Technical Note

Prepared by: **Rachel Canham**Date: **06 November 2024**Project: **NRS Lea Castle Farm**Ref: **5342**Page: **1 of 9**Subject: **Response to Inspector's request for further details about noise predictions**

This document provides a response to Inspector's request for further details about noise predictions for Lea Castle Farm.

Figure 2: Extract from Plant Site drawing showing field conveyor and conveyor tunnel

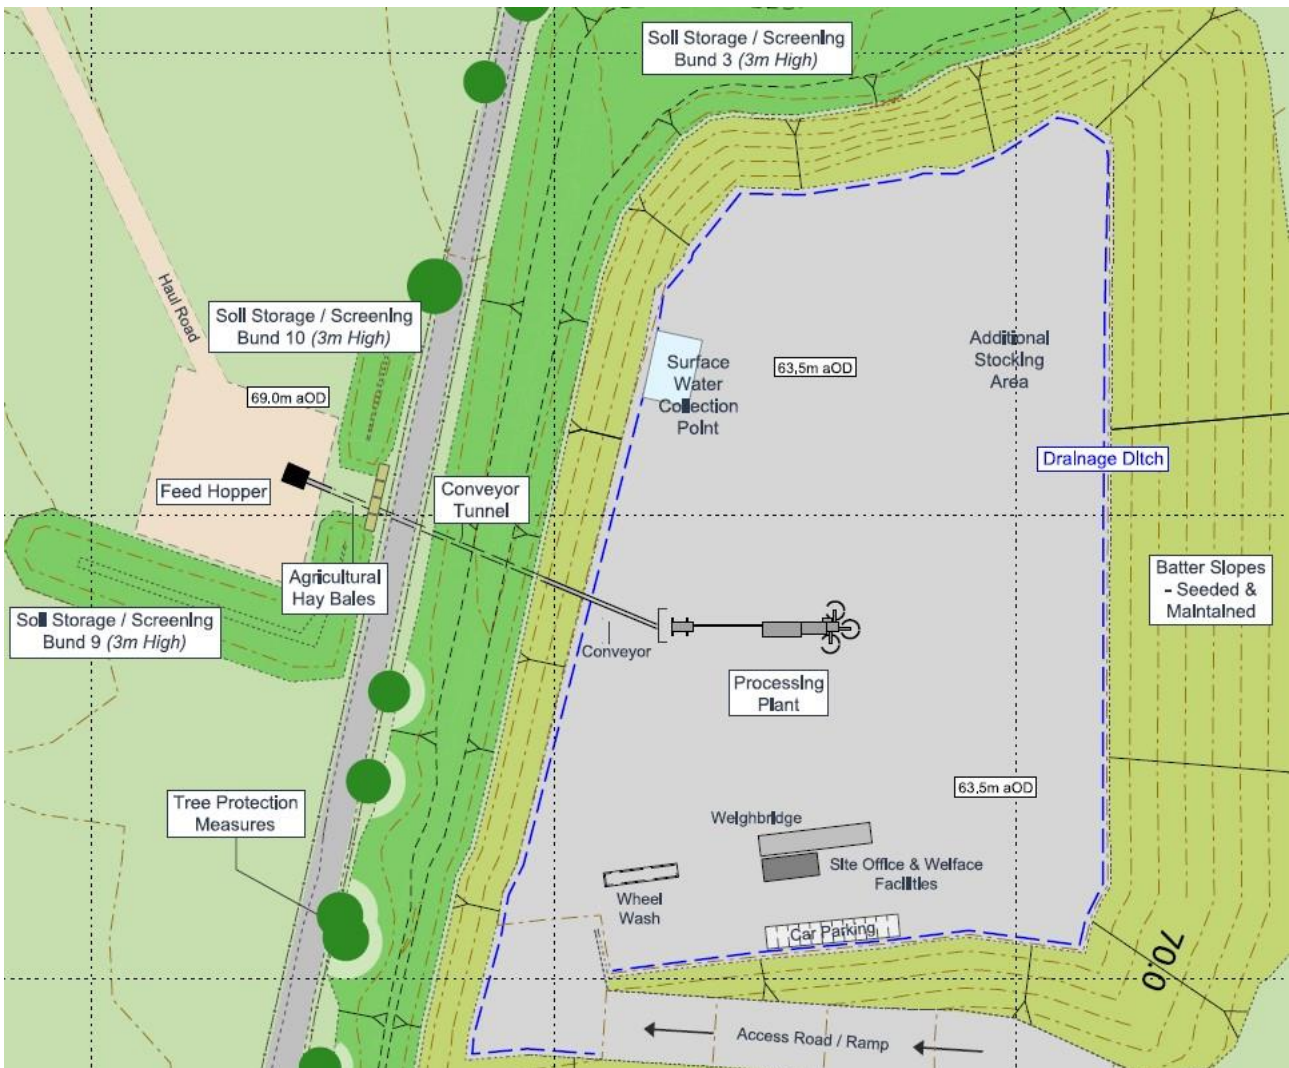
3. Appellant’s noise rebuttal PoE refers at para 5.22 to a 20 dB reduction in sound level on the Bridleway at 200 m distance from where the Bridleway crosses over the conveyor. The inspector requests a comparison between the predicted sound level at this conveyor cross-over point in the Bridleway with Bund 3 at a height of 6m and 3m, and whether these predictions, and the 20 dB reduction over 200 m, include the conveyor as a line source. Also whether the barrier attenuation takes account of frequency given that ES Addendum 5.3.21 refers to A weighted Sound Power Levels, dB LWA ‘Updated processing plan – crusher & sand plant’ 3.5m 100% 100 dB’ and ‘Updated processing plant – screen & conveyors’** 4.5m 100% 100 dB’ *** combined sound power level of 103 dB LWA for the processing plant.**

The field conveyor is shown in Figure 2 below, and shows the section of the conveyor in the tunnel under the brideway and bund 3.

The field conveyor connects the feed hopper and the processing plant. The conveyor is to be in a tunnel under the brideway and bund 3, as shown on Figure 2 above. The only part of this field conveyor that will be 'visible' to the brideway would be the small section to the west of the brideway between bunds 9 and 10 (both 3m tall), assuming negligible screening from the hay bales. The section of field conveyor outside the tunnel to the east of the brideway will be screened by bund 3.

For the calculation of noise levels arising from a conveyor, you need to consider the perpendicular distance to the line of the conveyor, and also the angle of view of the conveyor to the receptor. The calculation assumptions for the field conveyor to the west are as follows:

- The sound power level of the conveyor is assumed to be 74 dB L_{WA} per metre.
- Calculations have been undertaken at various perpendicular distances along the bridgeway from the crossover point with the conveyor: at 1m, 2m, 4m, 6m, 8m and 10m.
- The corresponding unscreened angles of view of the conveyor in the gap between bunds 9 and 10 are respectively 35°, 50°, 55°, 50°, 30° and 15°.

Distance	Angle of view	Calculated Level dB $L_{Aeq,T}$
1m	35°	62
2m	50°	60
4m	55°	58
6m	50°	56
8m*	30°	52
10m*	15°	48

With regard to the section of the field conveyor on the eastern side of the bridgeway, this will be fully screened from a receiver on the bridgeway by bund 3. It is estimated that the noise from the eastern section of field conveyor would be at or below 48 dB at the crossover point with a 3m bund, and assuming minimal screening from this bund. The noise level would be lower with a 6m tall bund, but it is not possible to provide an accurate estimate of the difference as the bund attenuation offered to the conveyor will depend on the relative height of the field conveyor to the bund apex and receptors (which may vary).
